South Texas Project Electric Generating Station P.O. Box 289 Wadsworth, Texas 77483

January 17, 2011  
U7-C-STP-NRC-110008

South Texas Project  
Units 3 and 4  
Docket Nos. 52-012 and 52-013  
Response to Request for Additional Information

Attached are responses to NRC staff questions included in Request for Additional Information (RAI) letter numbers 349 and 350 related to Combined License Application (COLA) Part 2, Tier 2, Sections 3.7 and 3.8. The attachments address the responses to the RAI questions listed below:

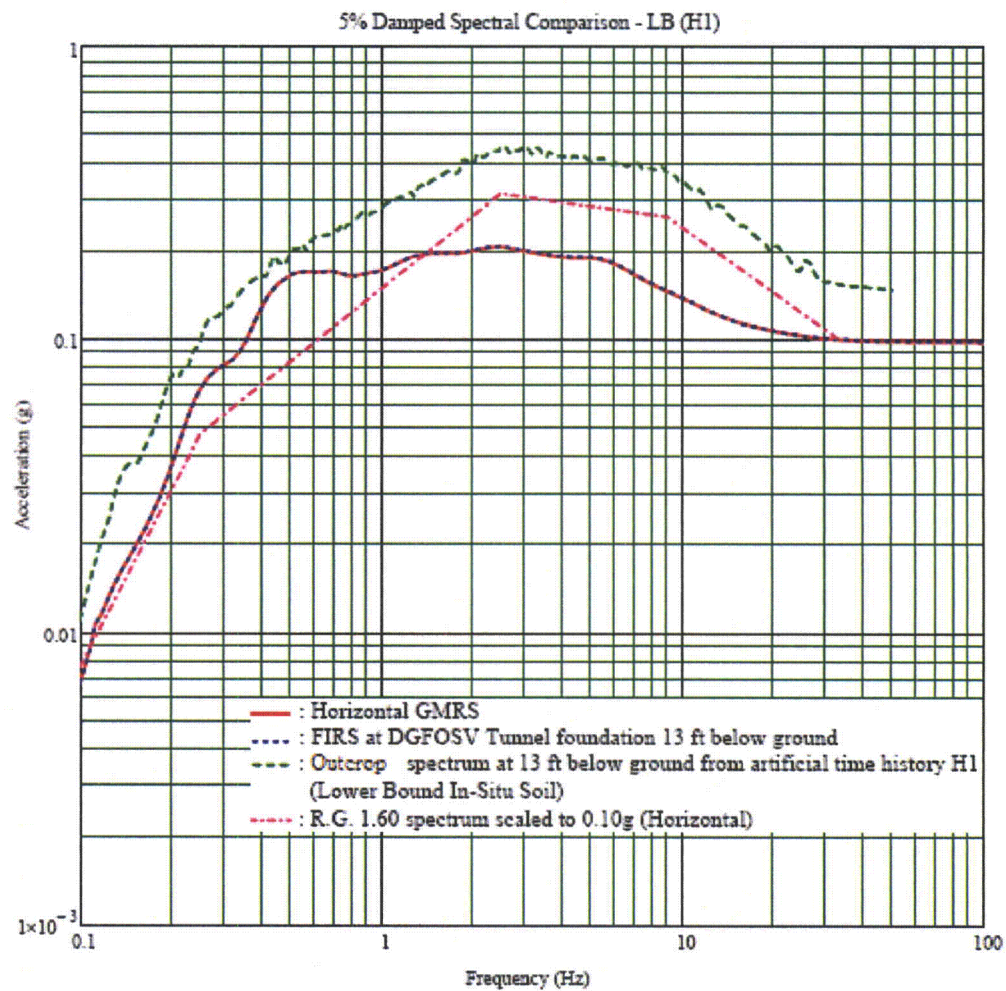
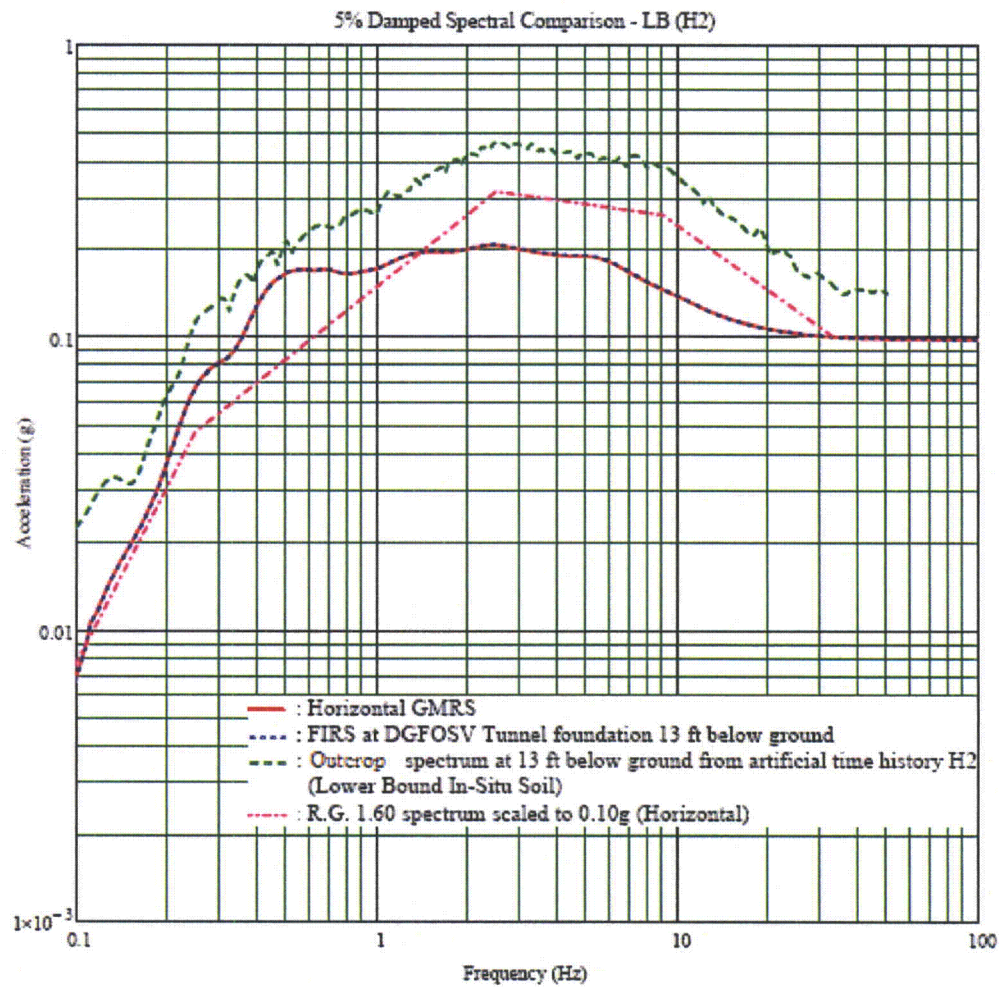
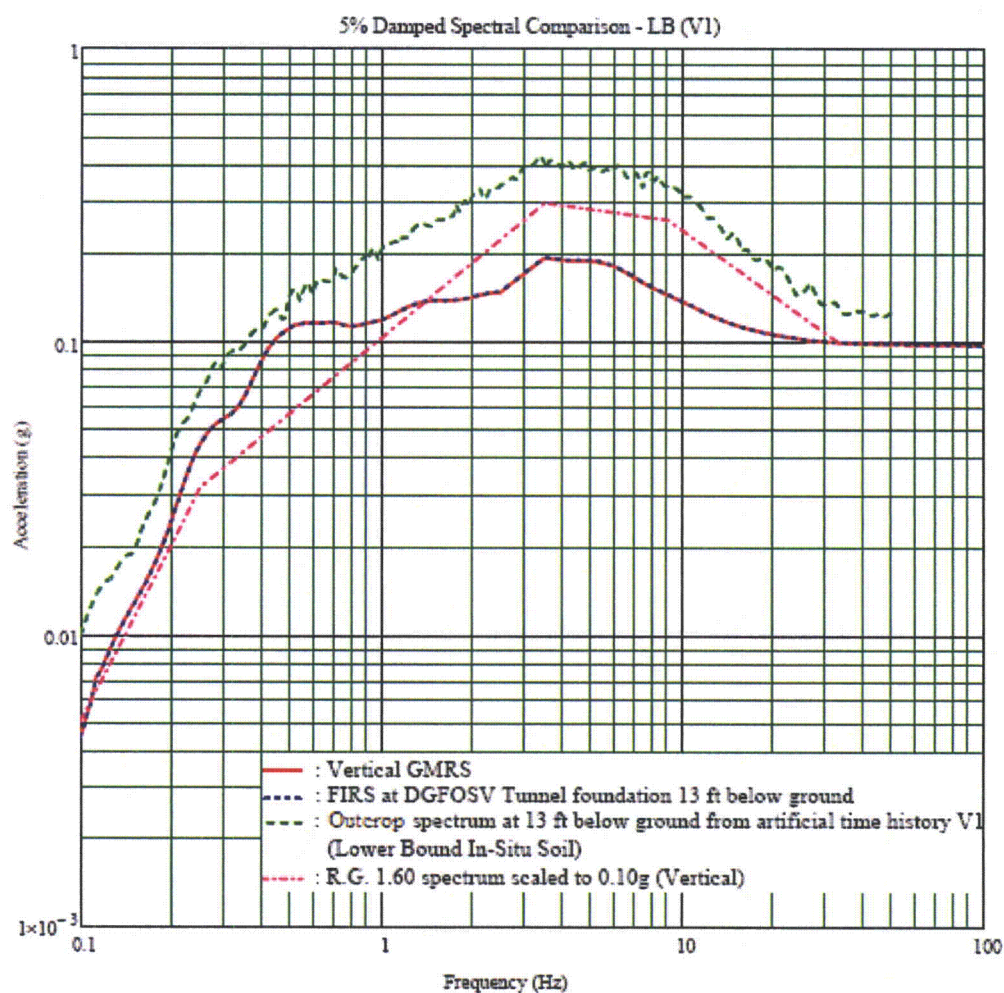
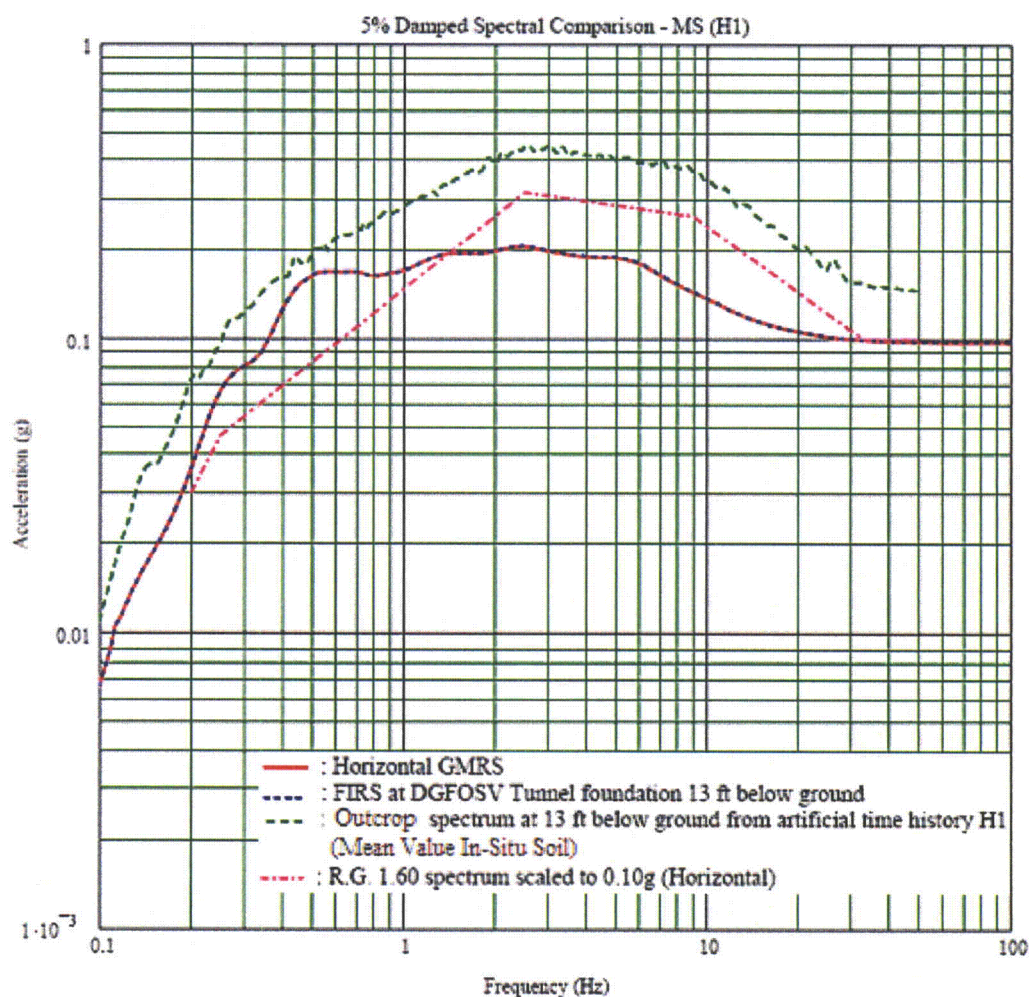
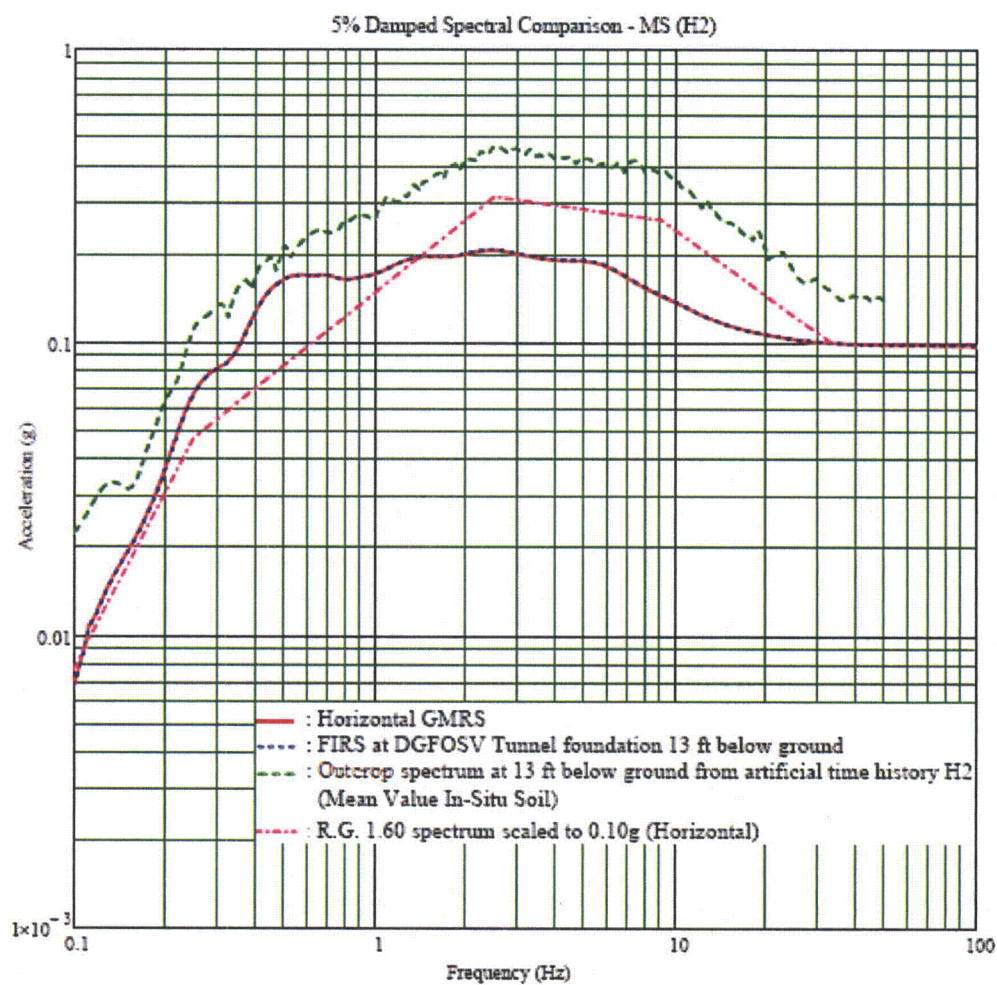
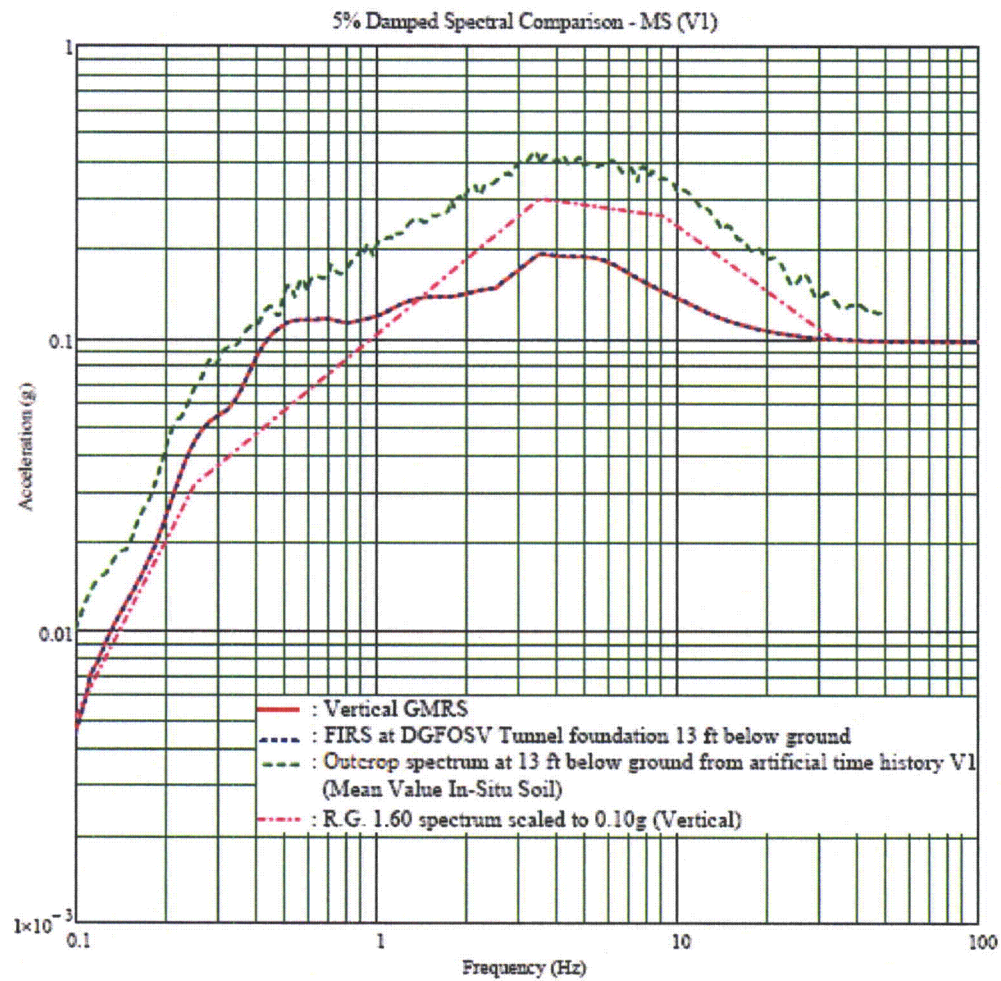
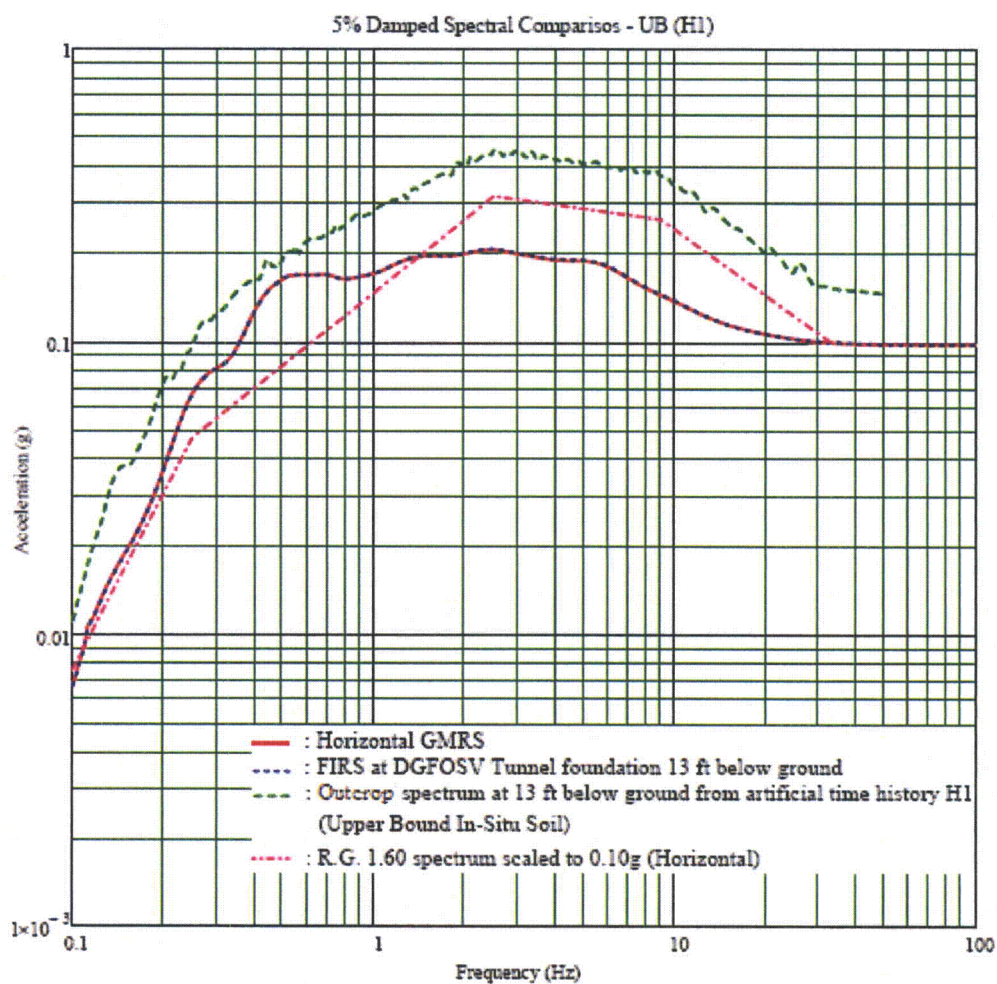
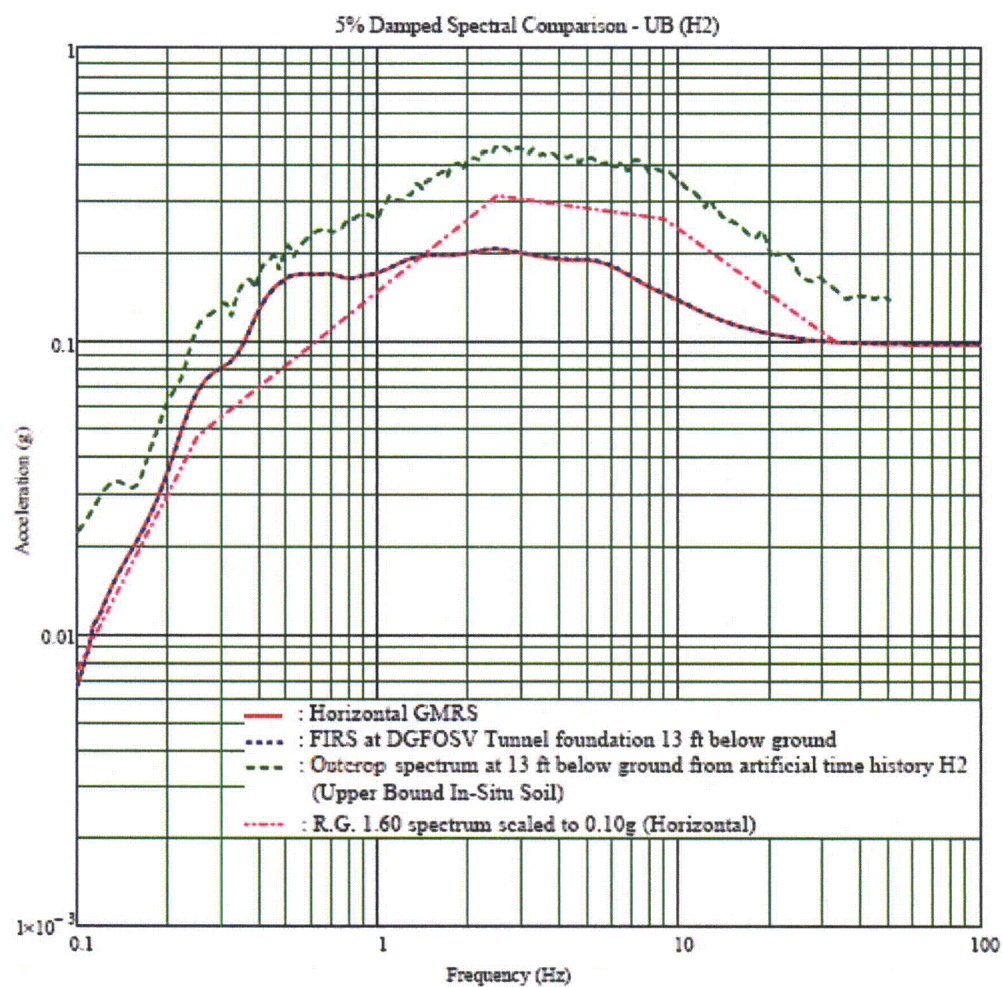
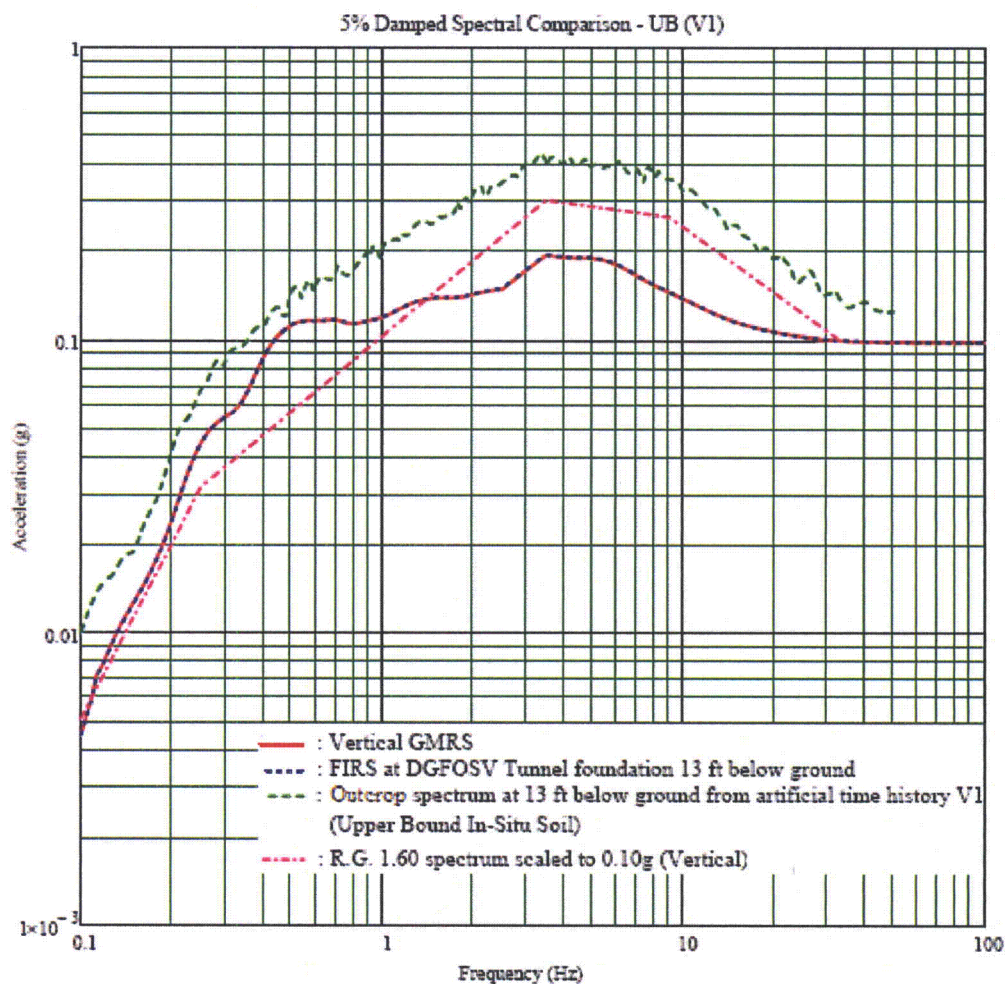
In response to an action item from the NRC's audit performed during the week of October 18, 2010, the following additional information is also included:

The foundation input response spectra (FIRS) for the DGFOT were calculated and were compared to the outcrop spectra at the foundation level of the DGFOT. The outcrop spectra were calculated from a deconvolution analysis performed in the SHAKE program with the site-specific SSE motion applied at the free field ground surface. Figures 3H.7-22 through 3H.7-32 show the comparison of the outcrop response spectra and the FIRS, in the two horizontal directions and the vertical direction for the lower bound, mean and upper bound in-situ soil properties. These figures show that the FIRS are enveloped by the foundation outcrop spectra in all cases. The figures also show that the response spectra at the SHAKE outcrop of DGFOT foundation level also envelop a broad band spectrum anchored at 0.1g. This is the minimum requirement as stated in SRP 3.7.1 and Appendix S to 10 CFR 50. The broadband spectrum used in this comparison is conservatively defined as the Regulatory Guide 1.60 spectrum anchored at 0.1g.
